Noise Feasibility Study

Milton North Business Park

Revised: December 19, 2023

Appendix C: Responses to Comments

Figure 5: Predicted Impulsive Sources Sound Level Contours, LLM [dBAI]

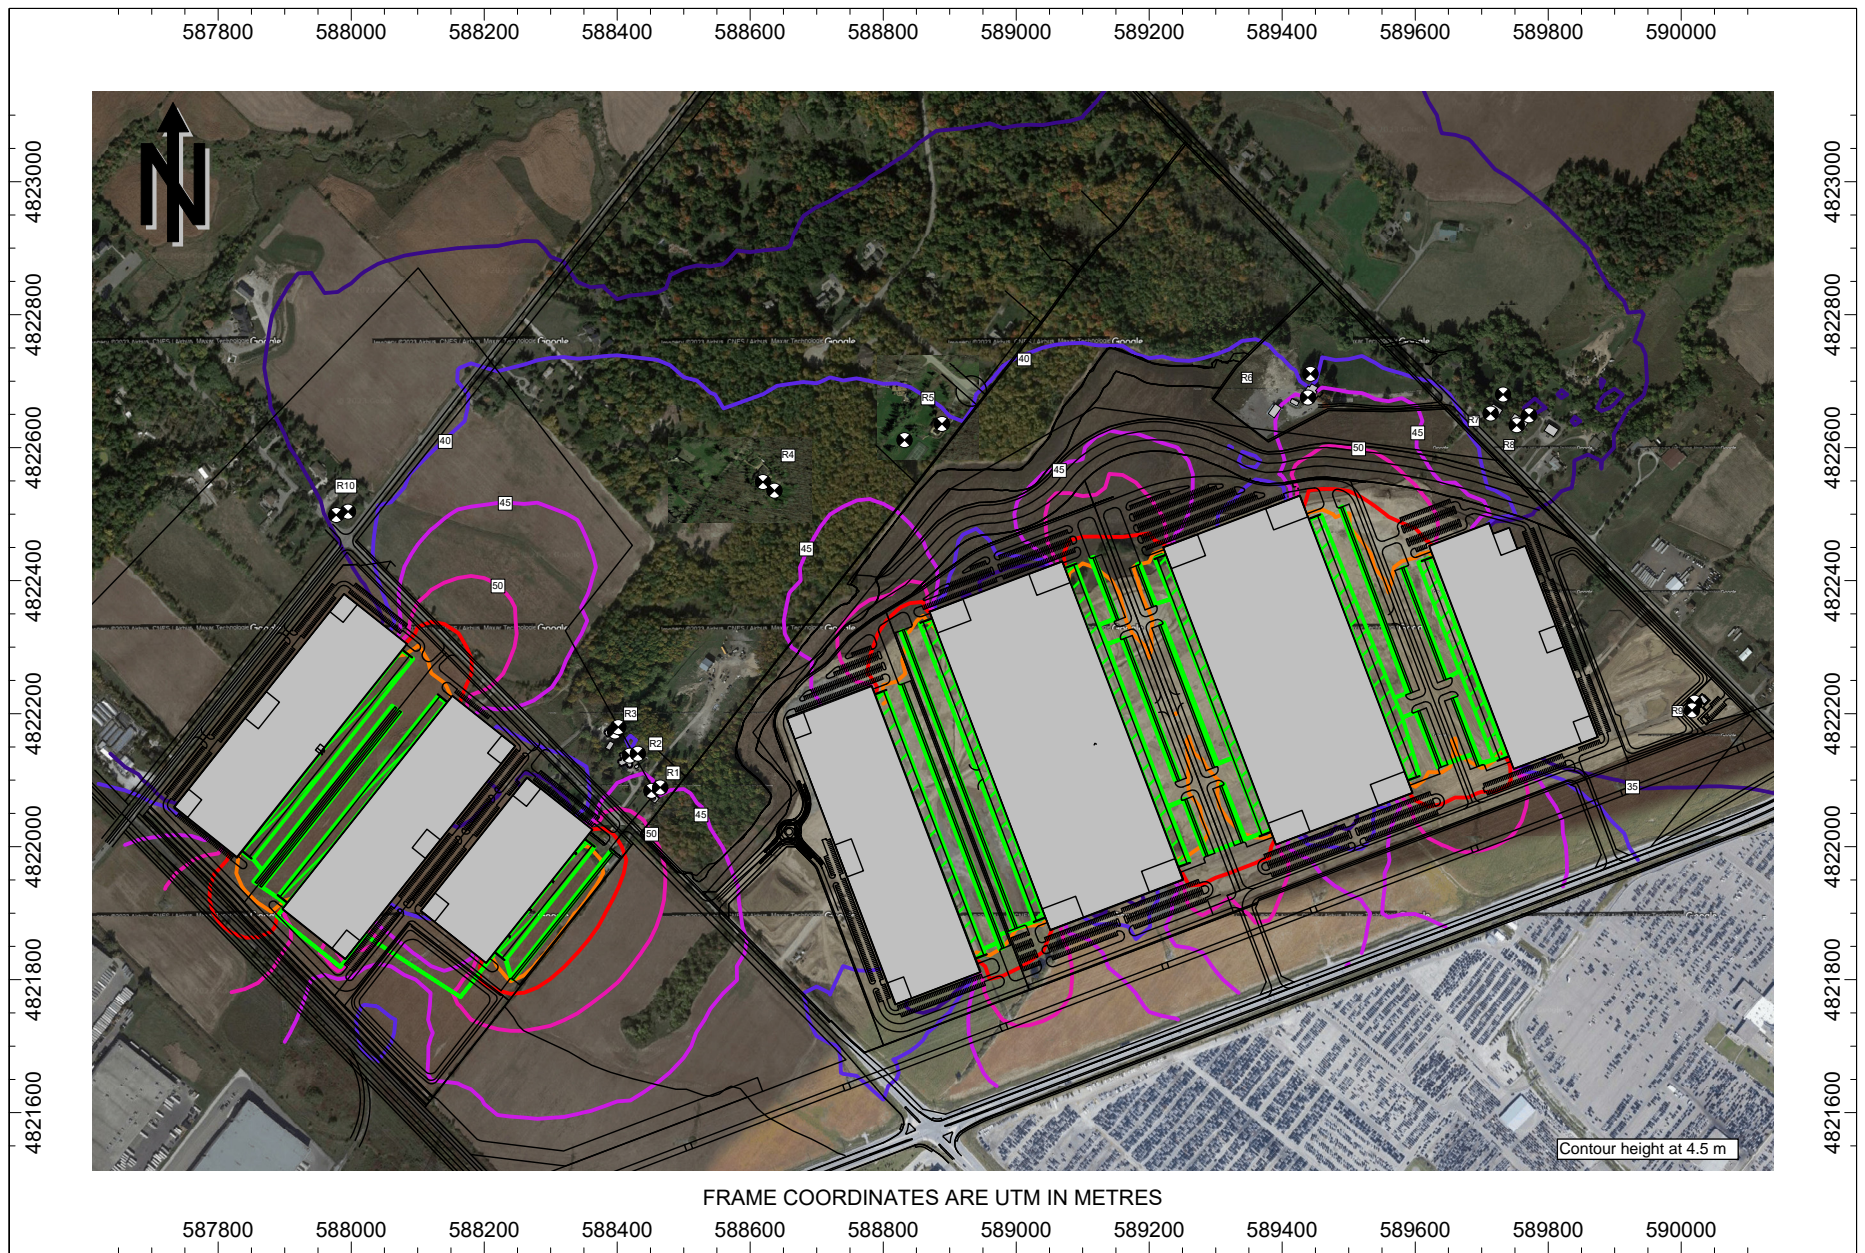
13) WSP agrees with the points of reception (PORs) chosen for the assessment for existing points of reception identified in Table 1, 3 to 5, and Figure 5 of the Noise Report. However, as noted in Table 3 to 5 and Figure 5 there are some inconsistencies as noted below. <i>Please provide a response.</i>	Receptor locations have been updated and shown in Tables 3, 4 and 5 and noted in Table 1. The previous R6 is noted and observed to be non-residential use per recent visit conducted in December 2023 and those lands are also noted to be zoned FD for Future Development.
